ADDENDUM NUMBER 4

**LINCOLN COMPLEX – BUILDING O O.A.R., LIBRARY SERVICES AND I.T.
RENOVATIONS
930-B Oak Street SE, Albuquerque, NM 87106
ALBUQUERQUE PUBLIC SCHOOLS**

APS RFP No. 21-031-RRR

Date of Issue: 12/15/2020

SKETCH SK-E-303-02

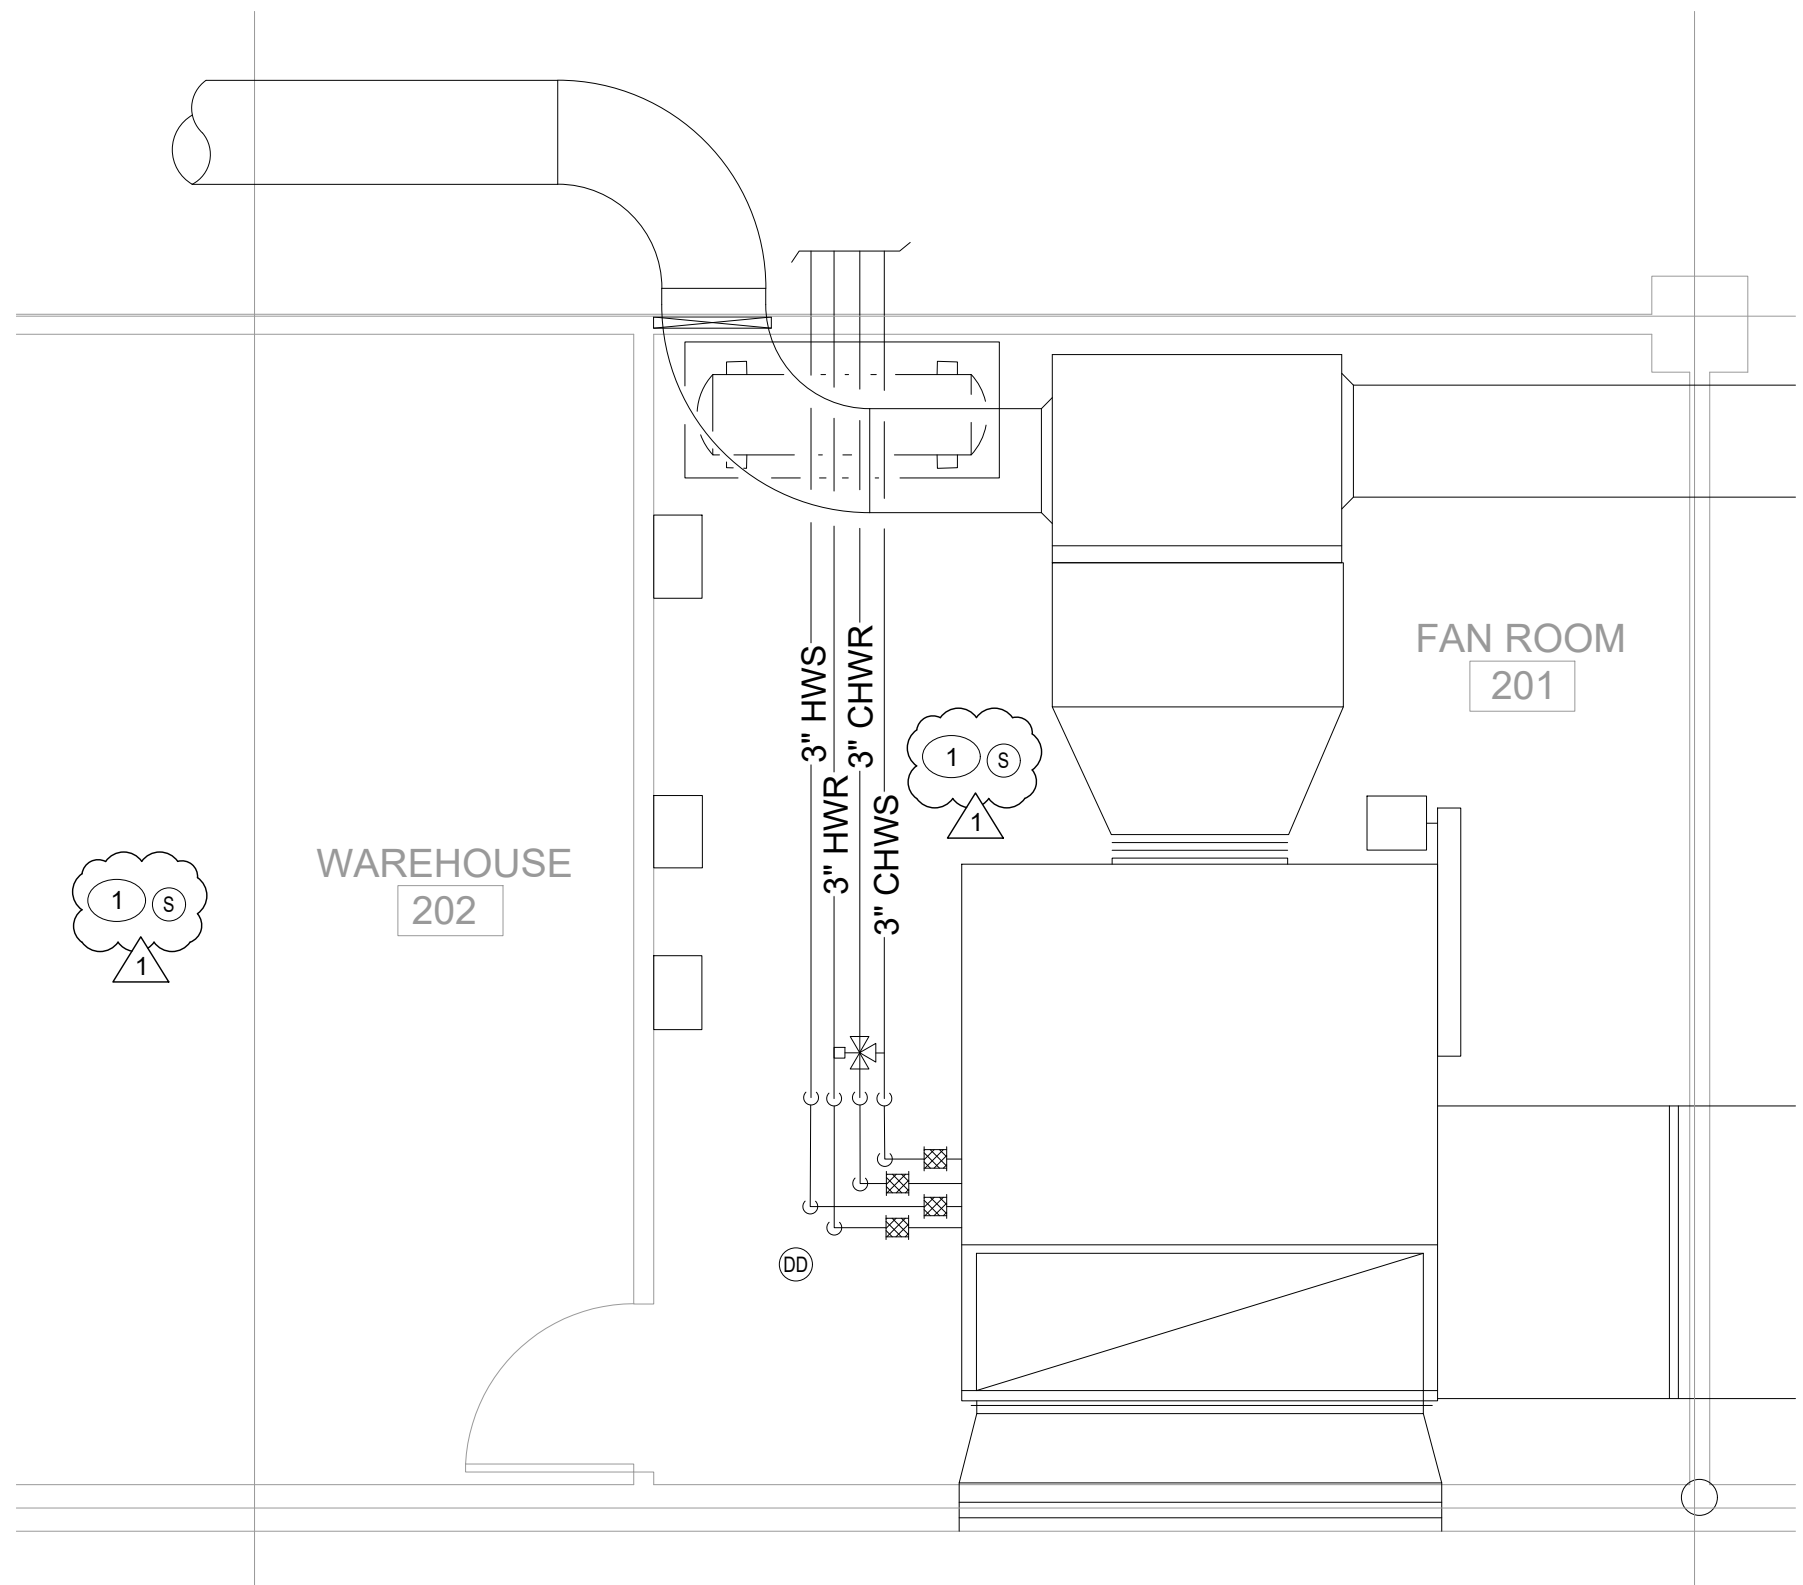
51) See attached sketch SK-E-303-02 for added smoke detectors.
